SERVICE BULLETIN

No. 487

Piper Aircraft Corporation

Control Shaft Collar Attachment Modification

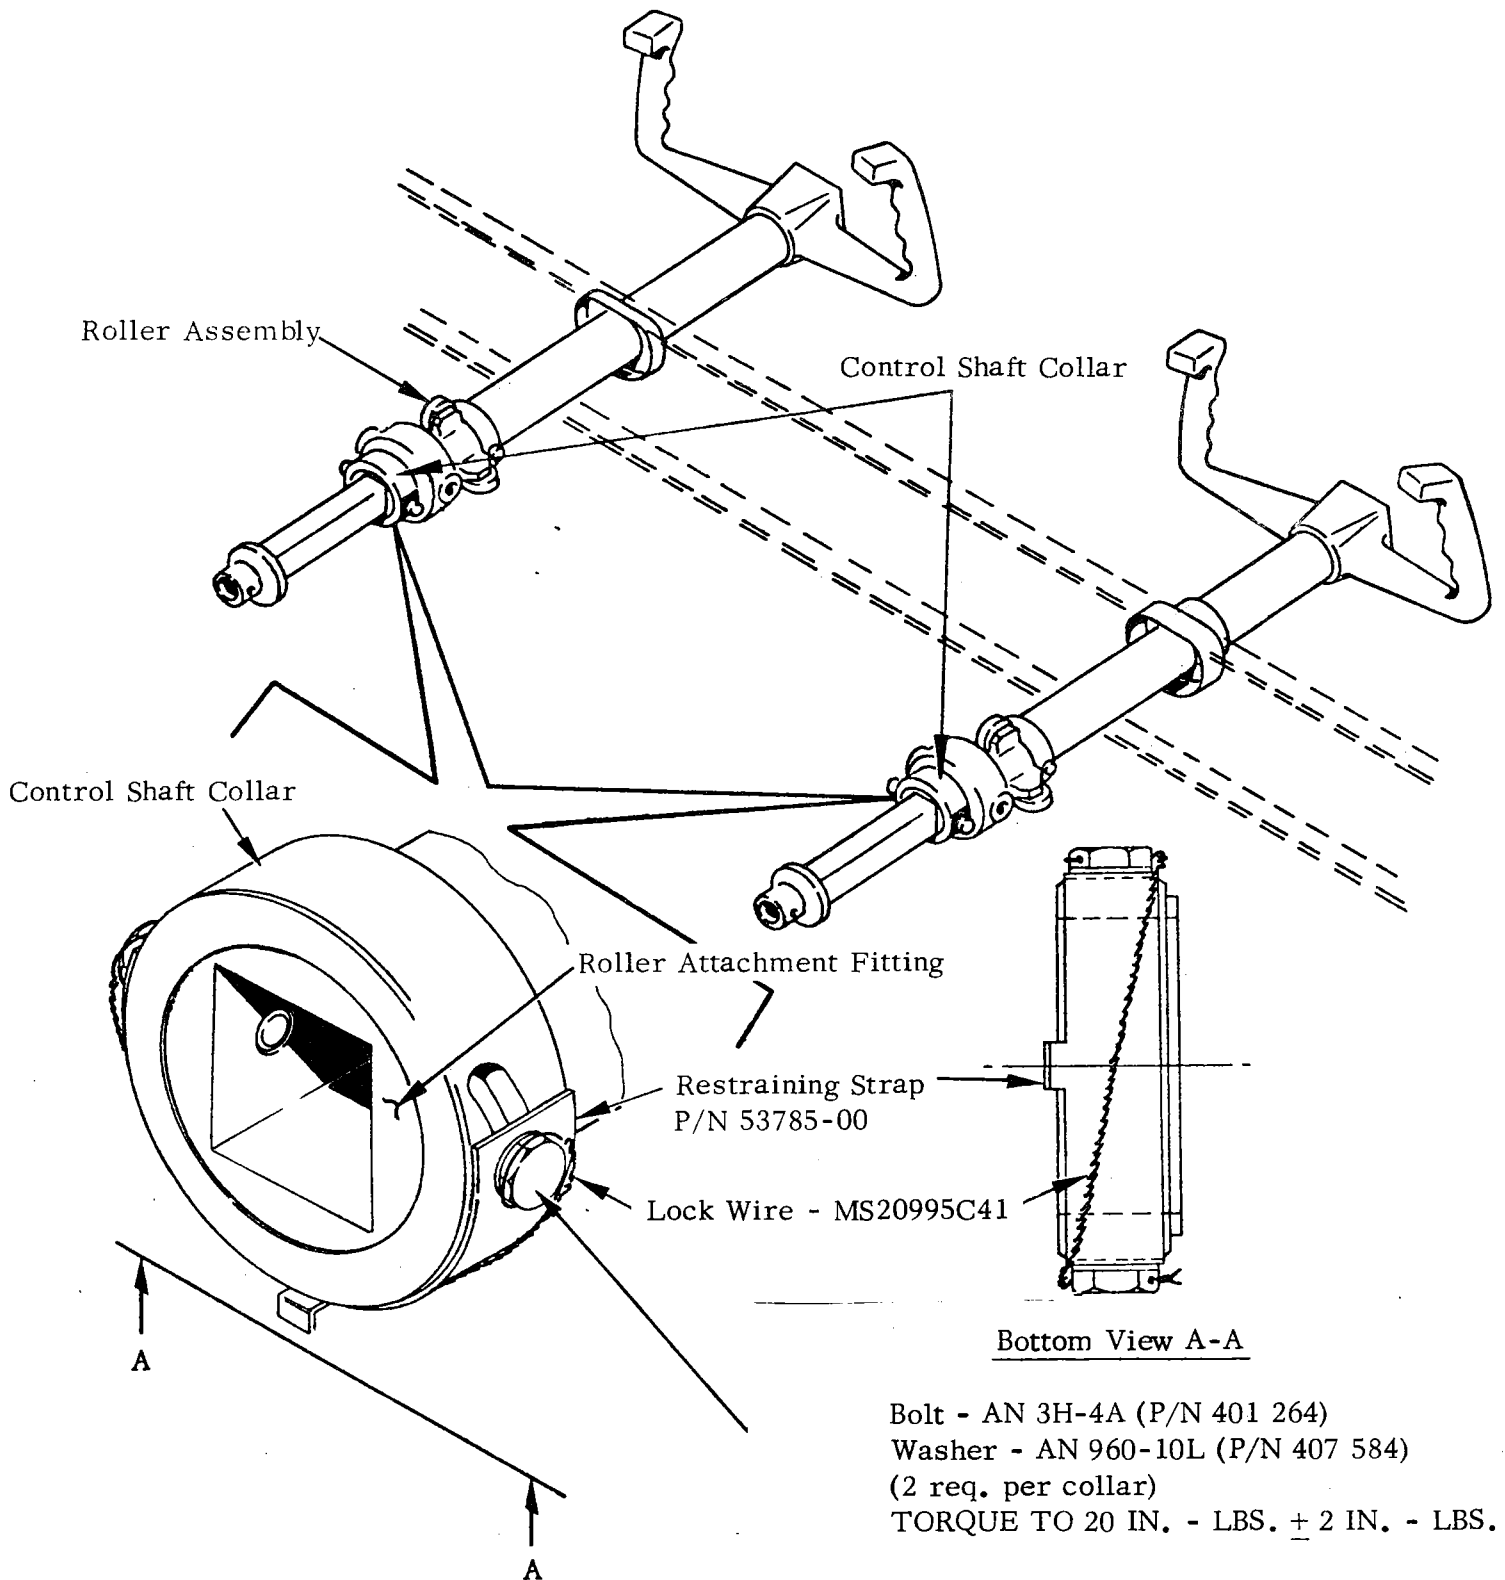
A recent report from the field indicates that the AN 3H3A bolts which attach the control shaft collar to the control shaft tube can be of insufficient length to allow proper bolt thread engagement. Should this condition exist, the bolts can become detached from the assembly, affecting control column function.

1. Refer to attached sketch; move control wheel to gain access to roller assembly. Rotate control wheel as required to gain access to each bolt.
2. Cut lock wire, as shown on sketch detail.

3. Remove AN 3H3A bolt and corresponding AN 960-10 washer.

Bolt - AN 3H-4A (P/N 401 264)
 Washer - AN 960-10L (P/N 407 584)
 (2 req. per collar)
 TORQUE TO 20 IN. - LBS. \pm 2 IN. - LBS.

NOTE: Inspect to insure that the bolts are not protruding through the Roller Attachment Fitting by placing a .040 feeler gage between the fitting and the square tube. Should the bolt protrude, add one (1) additional AN 960-10L washer under the head and recheck clearance at 20 IN. - LBS. \pm 2 IN. - LBS.

4. Install AN 3H4A bolt (Piper part number 401 264) and AN 960-10L washer (Piper part number 407 584).
 5. Using a 3/8" socket and a low-scale, inch-pound torque wrench, tighten bolt to 20 inch-pounds \pm 2 inch-pounds; if this torque value can be maintained without stripping the threads repeat steps 3, 4, and 5 on other bolt.
 - a. If 20 inch-pounds \pm 2 inch-pounds torque value cannot be maintained on either bolt, contact the factory (Lock Haven Facility) Customer Service Dept. for further information.
 6. After completion of above steps, lock-wire bolts (see sketch).
 7. Repeat steps 1 through 6 with other control wheel.
 8. Make appropriate log book entry indicating compliance with this Service Bulletin.
1. Four (4) each per aircraft AN 3H4A bolt, Piper part number 401 264;
 2. Five (5) each per aircraft AN 960-10L washer, Piper part number 407 584.
